COLLIN COUNTY, TEXAS

ADDENDUM No. Two (2)

Construction, Road: Outer Loop Access Road, US 75 to SH 121

DATE: October 18, 2010

PROPOSED TYPICAL SECTIONS			
SHEET 4 OF 7			
HNTB			
<small>HNTB Corporation The HNTB Companies Engineers Architects Planners Fire Registration Number 420</small>			
BOND PROJECT NO.		SHEET 4

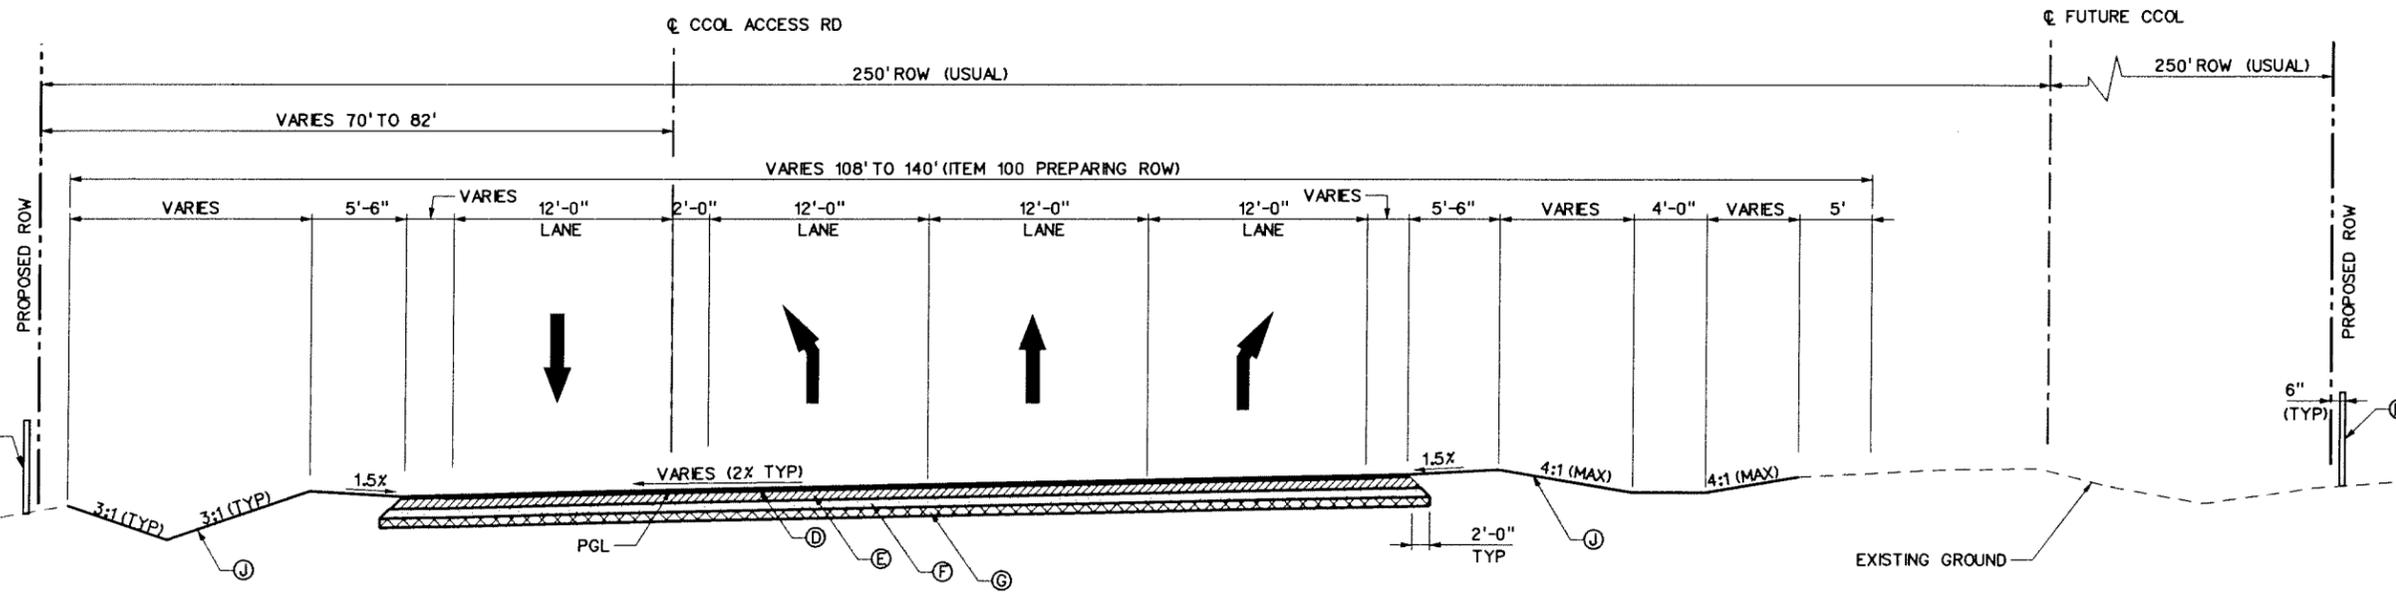
A. Proposed Typical Sections (Sheet #9) – Prime Coat (MC-30)(TYP) is to be added to the top of the 6" FL BS (TY A) layer on all Asphalt Pavement sections.

**ACCESS ROAD
PAVING PLAN & PROFILE
BEGIN PROJECT TO STA 22+00**

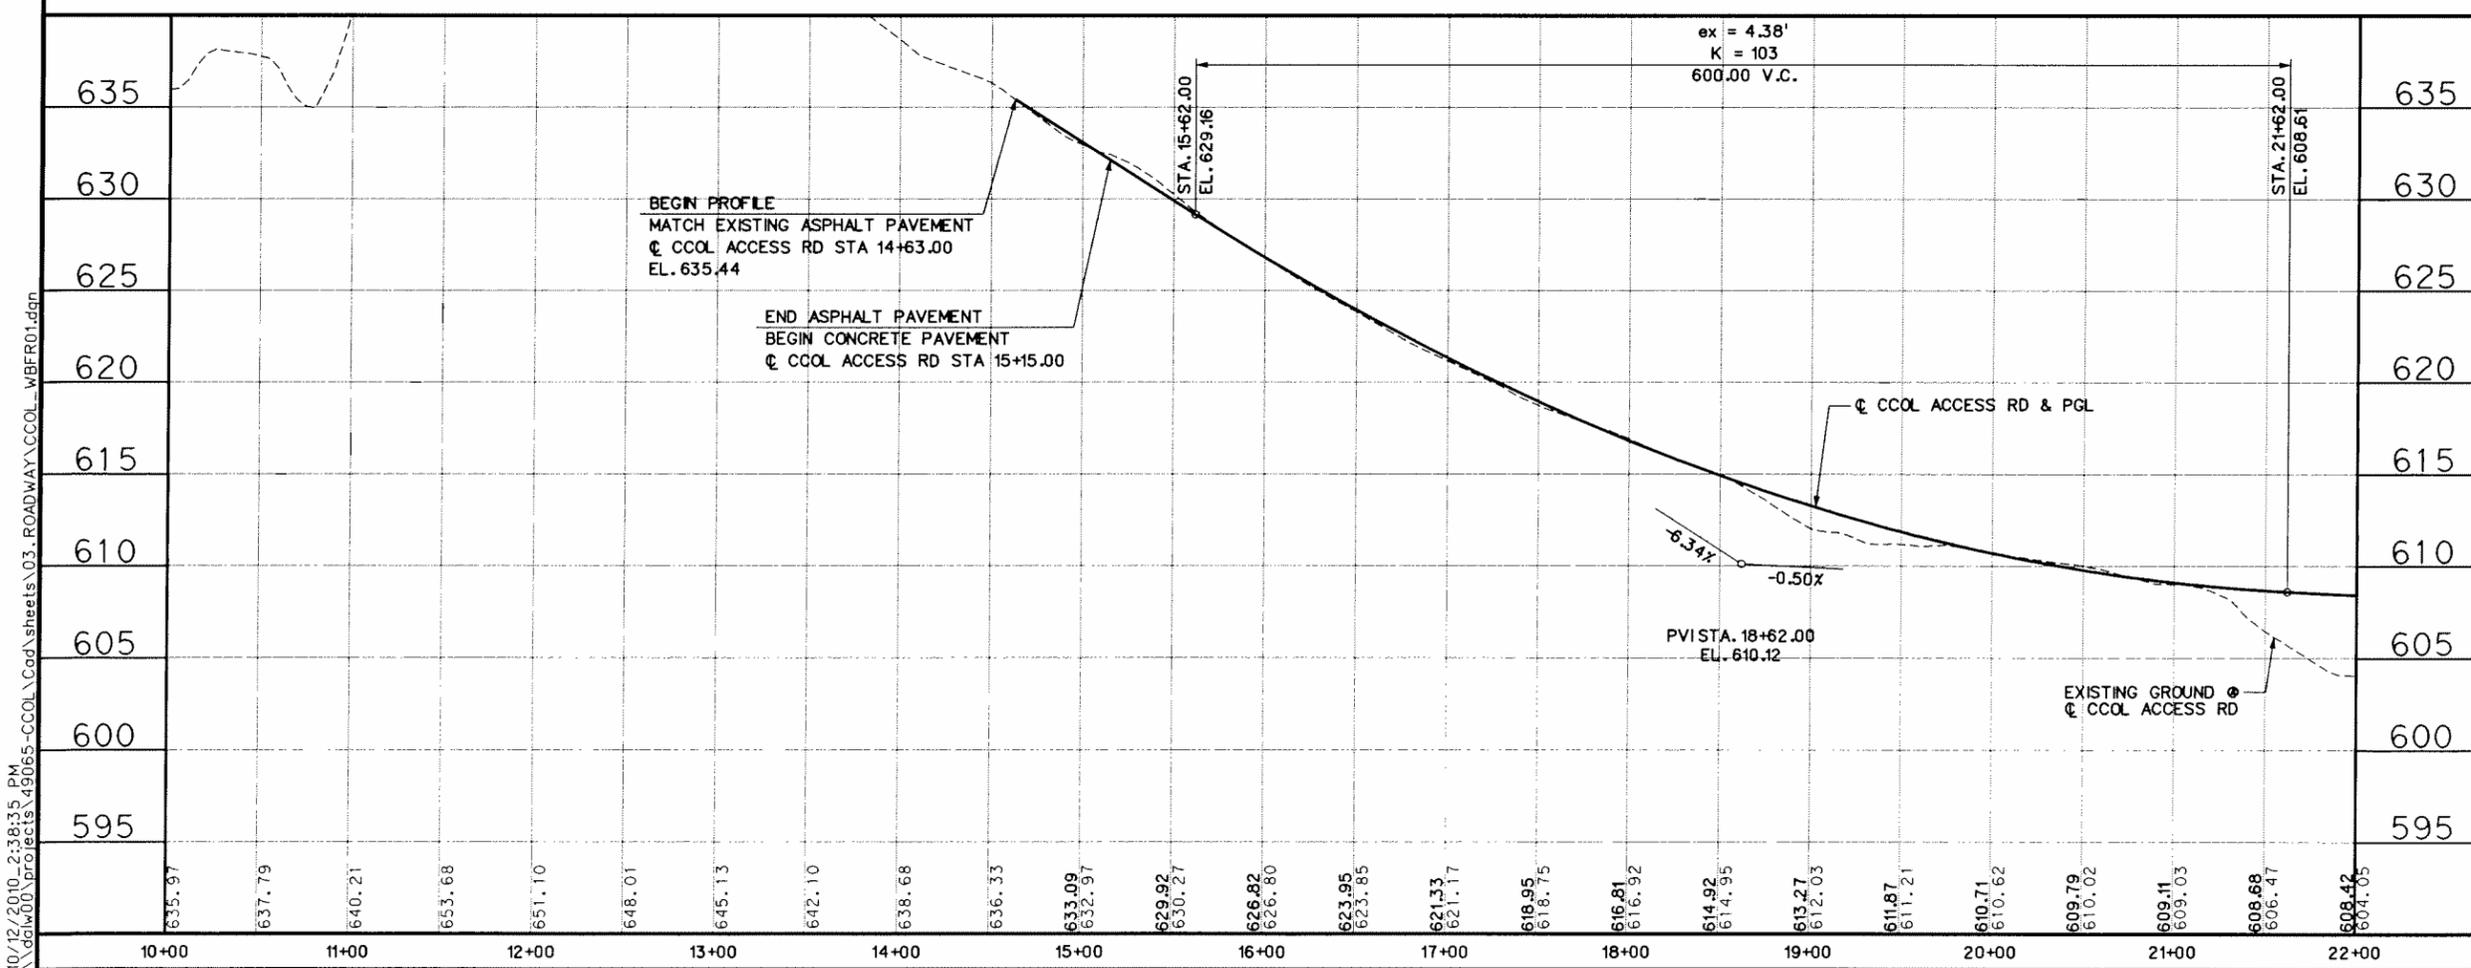
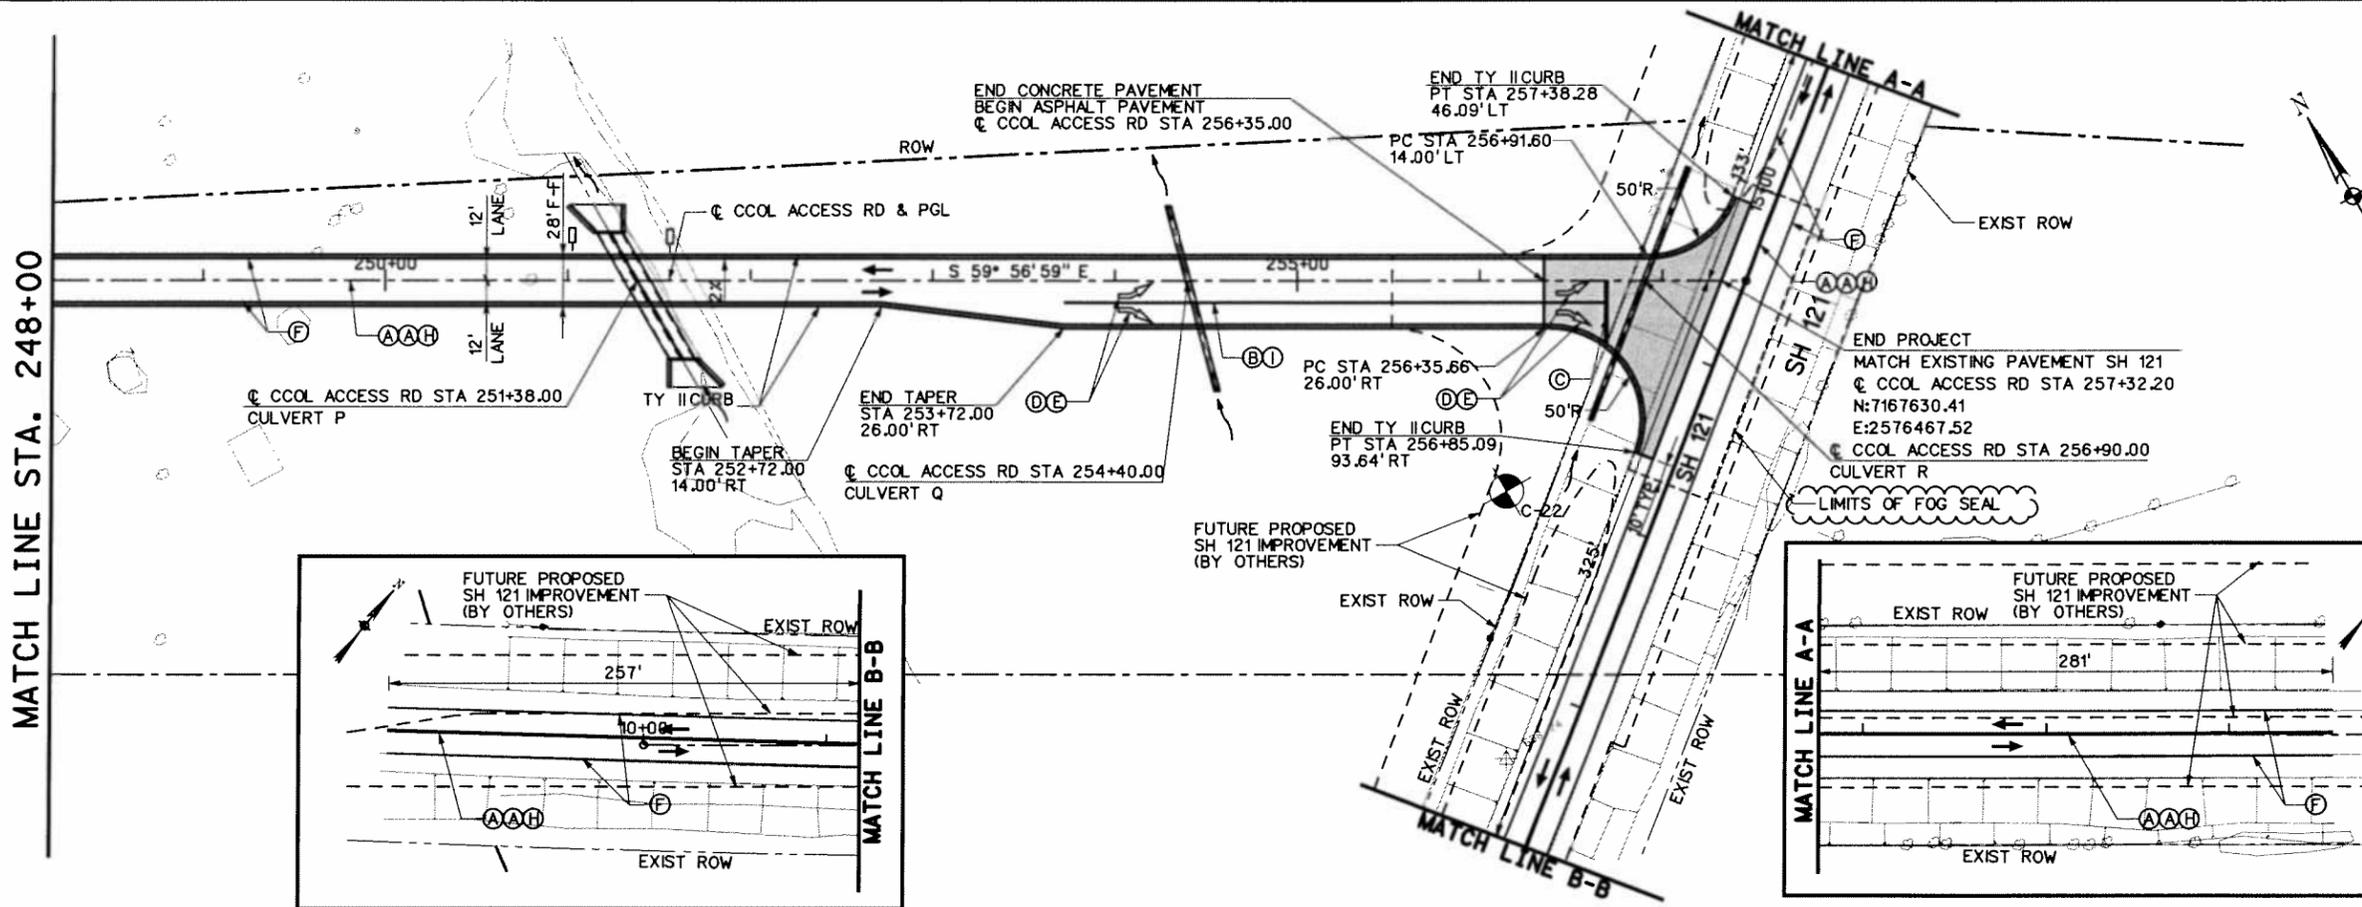
Sheet 65 shows some "seal coat" and the TCP Narrative references this as the final construction element. How is this work measured and paid? **(Submitted: Oct 8, 2010 10:17:44 AM CDT)**

- D. Access Road Paving Plan & Profile (Sheet #65) – The callout for seal coat area at the intersection with the US 75 Northbound Frontage Road has been revised to Fog Seal (Typ).
 - E. Access Road Paving Plan & Profile (Sheet #85) – The callout for seal coat area at the intersection with SH 121 has been revised to Fog Seal (Typ).
 - F. Miscellaneous Roadway Details (Sheet #101) – A detail for the Construction Safety Fence has been added to the sheet.
 - G. MC-10-23 Standard (Sheet #217) – Replace with MC-10-7 Standard for Multiple Box Culverts, Cast-In-Place, 10'-0" Span from 0' to 7' Fill.
4. Construction Time Determination
- A. The documentation for the construction time determination has been attached.

- Seal Coat area at SH 5 shall be resurfaced with the 2" D-GR HMA (TY-D) with FOG SEAL (SS-1) as shown on the Proposed Typical Section. The Seal Coat areas at US 75 and SH 121 will be resurfaced with FOG SEAL (SS-1) only. The changes will be reflected in Addendum #2. **(Answered: Oct 13, 2010 8:22:31 AM CDT)**

NO.	DATE	REVISION	APPROV.
COLLIN COUNTY OUTER LOOP			
 COLLIN COUNTY			
MISCELLANEOUS ROADWAY DETAILS			
SHEET 1 OF 1			
HNTB			
HNTB Corporation The HNTB Companies Engineers Architects Planners Firm Registration Number 420			
BOND PROJECT NO. 07-094		SHEET 101

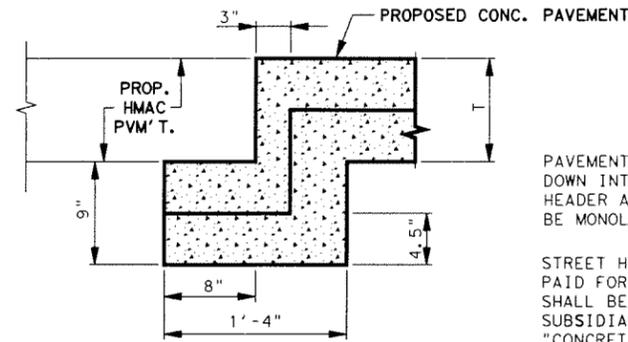
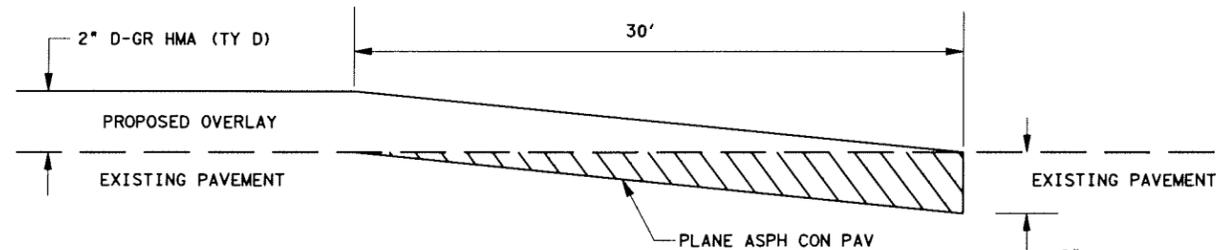
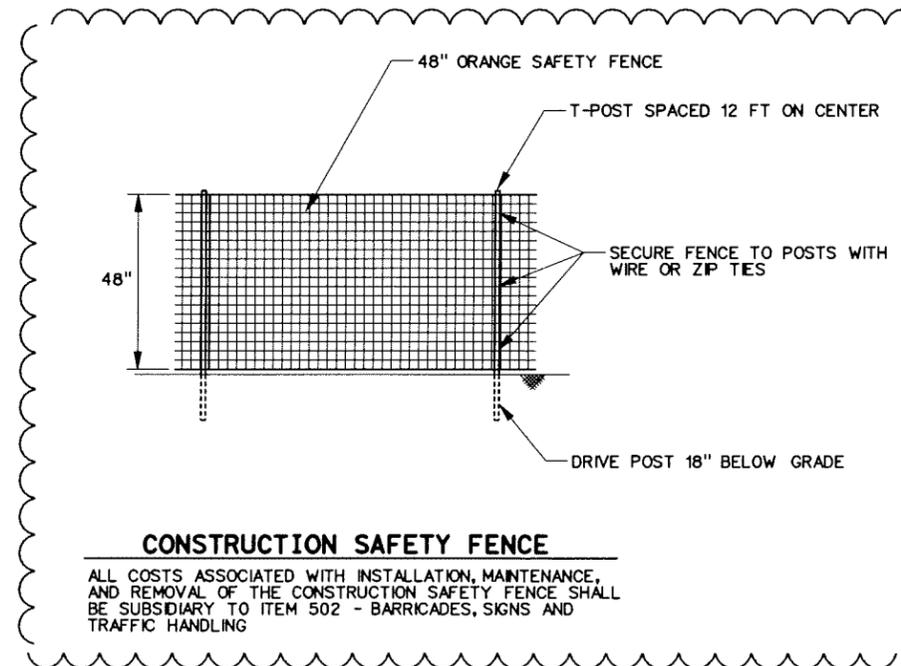
There are approximately 2,035 linear feet of "construction safety fence" required on sheets 79-81. I didn't locate a detail for this item. Please clarify what we are to provide for this requirement. **(Submitted: Oct 8, 2010 10:20:47 AM CDT)**

- The contractor shall use a 48" high orange safety fence secured with wire or zip ties to T-Post stakes spaced 12 ft on center. The contractor shall install and maintain the fence throughout the duration of adjacent construction activities. A detail will be released in an addendum. **(Answered: Oct 8, 2010 3:08:48 PM CDT)**
